## MEMORANDUM

**RE: BUILDING DEMOLITION REVIEW**  
**1 Rear Coffin Avenue (Map 100 Lot 117) Circa 1902 masonry mill building**

Subject: Survey Board Report  
1 R Coffin Avenue, New Bedford, MA

Subject: Building Inspection  
1 R Coffin Avenue  
New Bedford, MA

**1** Holes in roof at Northwest corner of building and sawtooth roof beyond (facing East)

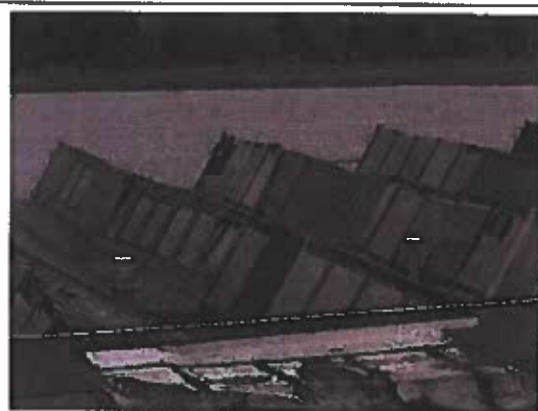
Photos 1 through 3 on Page 2 herein are presented in a panoramic sweep from East-to-Southeast-to-South in order to provide acclimation to the roof layout and show overall roof conditions, while Photos 4 through 6 show some of the peaks of sawtooth roof systems that are misaligned and out of level. Photos 7 through 9 on Page 3 show several large holes through a flat roof and expanses of sawtooth roof systems that have collapsed.

A summary of survey findings is quite simply that large areas of the roof structural systems have collapsed and that many other areas of roof structures continue to deflect out of alignment from their baseline positions that I observed when I first inspected this building 6½ years ago. One area of sawtooth roof systems that has collapsed at the South end of the building as shown in Photo 9 encompasses an area that I estimate to be approximately 5,000 square feet. Ongoing deterioration of other areas of this building can easily be gauged by referring to the information contained within my April 14, 2019 letter to you that I have attached to this document, which includes my several other letters that were dated February 15, 2013 and December 24, 2014 and March 23, 2015.

As I stated in my April 14, 2019 letter, this building is a danger to life or limb. I have accordingly joined Survey Board members in signing a document declaring that the building is dangerous as prescribed by provisions of the State Building Code since it has partially collapsed and it is unused, uninhabited or abandoned, and open to the weather. As such, I recommend demolition of this unsafe building as soon as possible.

**8** Typical water-stained roof sheathing boards at valley near beam supporting sawtooth roof

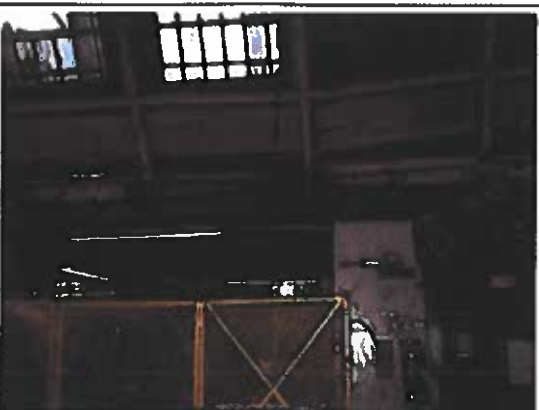
3. Water has also infiltrated many areas of the sawtooth roof system above the main factory. Photos 5 and 6 show water stains and mold growth in areas towards the South end of the building, while Photos 7 and 8 on Page 6 show several stained roof sheathing boards and other roof members near beams that support valleys of the sawtooth roof system.

**7** Hole through sagging roof is near middle of the 9<sup>TH</sup> sawtooth gable from the North end of the building and the adjacent peak of the 10<sup>TH</sup> gable is sagging (facing South)

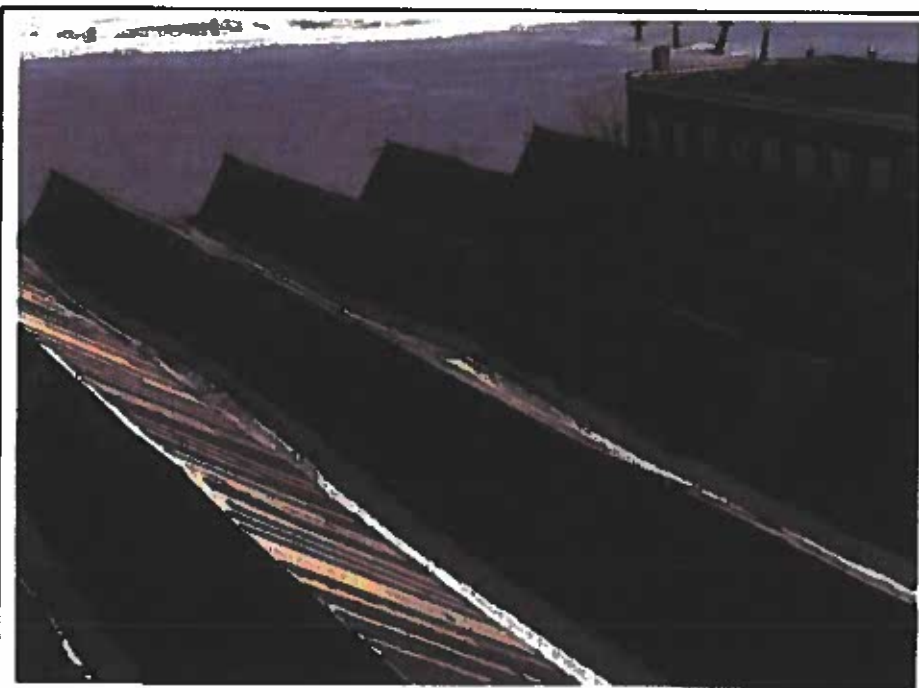
Photo 2 shows a hole through a sagging roof near the middle of the 9<sup>th</sup> sawtooth gable from the North end of the building and the misaligned adjacent peak of the 10<sup>th</sup> gable. Since this area is located near the South of the middle third of the building, it appears to be near the floor slab failure that I described in Item 4 of the Survey Findings in my December 24, 2014 letter to you. As such, the adjacent framing and foundation systems may be failing.

As I have continuously recommended since my initial survey of the building almost 2½ years ago, the building owner must be held accountable to take all actions required to comply with requirements of the State Building and Fire and Sanitary Codes. Since you have danced this dance with him for several years, it is time to stop the music and have him pay the piper.
